## ***Environmental Planning Commission***

***Agenda Number: 5  
Project Number: 2020-004017  
Case Number: SI-2020-00528  
September 10, 2020***

### ***Supplemental Staff Report (to be read in conjunction with the original Staff report)***

<b><i>Agent</i></b>	Consensus Planning
<b><i>Applicant</i></b>	City of Albuquerque Police Department
<b><i>Requests</i></b>	<b>Major Amendment to Site Plan-EPC</b>
<b><i>Legal Description</i></b>	Parcel 2-A and a portion of Parcel 2-B, Plat of Parcels 2-A and 2-B of Van Buren School Lands of Board of Education, located at 800 Louisiana Blvd. SE, between Kathryn Ave. SE, and Louisiana Blvd. SE, approximately 2.5 acres (L-18) and (L-19)
<b><i>Location</i></b>	Between Kathryn Ave. SE and Louisiana Blvd SE.  800 Louisiana Blvd. SE
<b><i>Size</i></b>	Approximately 2.5 acres
<b><i>Existing Zoning</i></b>	NR-SU

ALBUQUERQUE  
POLICE DEPARTMENT  
SOUTHEAST AREA  
SUBSTATION

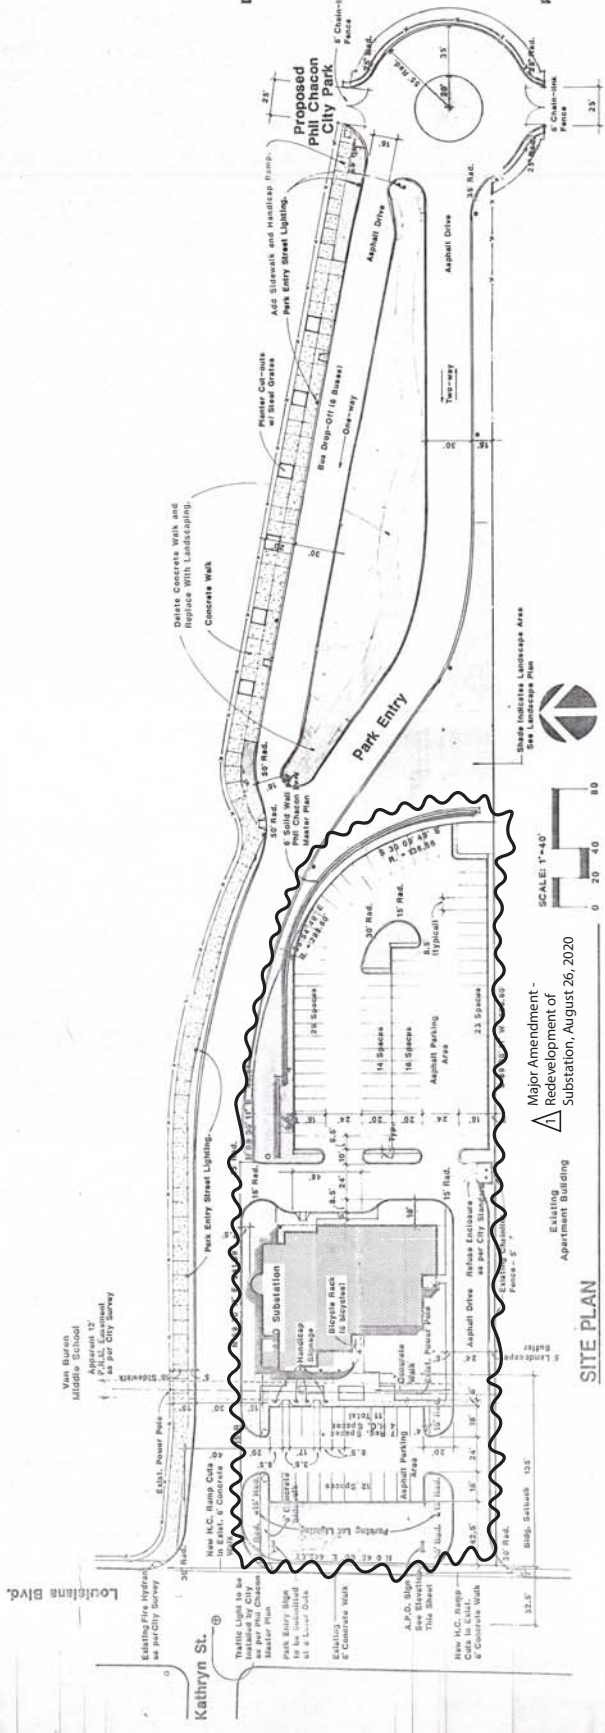
- **Condition 6:** “The subject site shall be called out on the governing site plan.”

We have added a cloud line around the subject site on the 1989 Site Plan and a note with the date of the proposed major amendment (*see Site Plan package, sheet 2*). The Applicant requests that Planning staff remove this condition as its been met on the revised Site Plan.
